# Access Compliance Report

## Public Rights-of-Way

Intersection ID: 48985	Main Street: AVONCLIFF_DR	Cross Street: KINGSDOWN_AV	Location: NE
ADA ID: 2A5BDB0BF1F3	Ramp Type: Perp	Initial Pass/Fail: Fail	Overall Compliance: No
Severity Score: 37.5			
Codes/Mitigation Info/Possible Solution		Field Measurements/Component Compliance

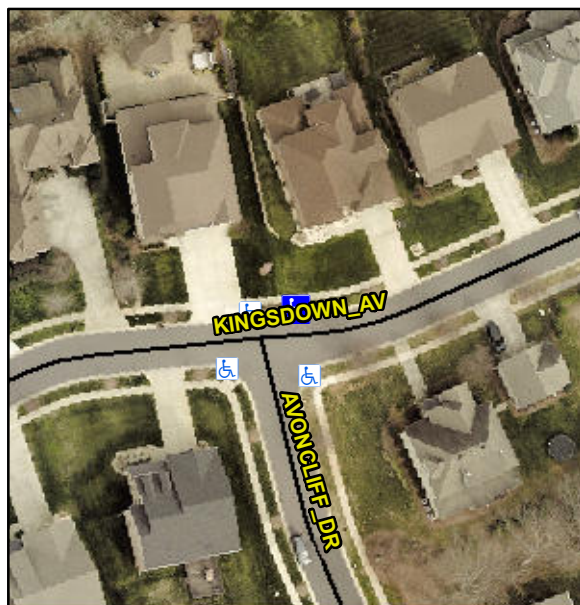
**Not Found, R304.2.2, R304.5.3**

Compliance	Description	Data	Compliance	Description	Data
N/A	Ramp Length (in)	69.0	No	Ramp Slope (%)	8.7
Yes	Ramp Width (in)	48.0	No	Ramp XSlope (%)	7.0
N/A	Flare Type LT	N/A	N/A	Flare Type RT	N/A
N/A	Flare Slope LT (%)	N/A	N/A	Flare Slope RT (%)	N/A
N/A	Flare Traversable LT?	N/A	N/A	Flare Traversable RT?	N/A
N/A	Landing Length (in)	N/A	N/A	DWS Provided?	N/A
N/A	Landing Width (in)	N/A	N/A	DWS Contrast?	N/A
N/A	Landing Slope (%)	N/A	N/A	DWS Length (in)	N/A
N/A	Landing X Slope (%)	N/A	N/A	DWS Full Width?	N/A
N/A	Landing Curb? (Y/N)	N/A	N/A	DWS Offset (in)	N/A
N/A	Shared Landing?	N/A			
N/A	Gutter Ponding?	N/A	N/A	Gutter Slope (%)	N/A
N/A	Gutter Lip Ht (in)	N/A	N/A	Gutter X Slope (%)	N/A
N/A	Painted X Walk1?	No	N/A	Painted X Walk2?	N/A
	X Walk 1 Direction	To S		X Walk 2 Direction	N/A
N/A	X Walk 1 Width (in)	N/A	N/A	X Walk 2 Width (in)	N/A
	X Walk 1 Slope (%)	2.7		X Walk 2 Slope (%)	N/A
	X Walk 1 X Slope (%)	6.0		X Walk 2 X Slope (%)	N/A

**Remove & Replace Entire Ramp.**
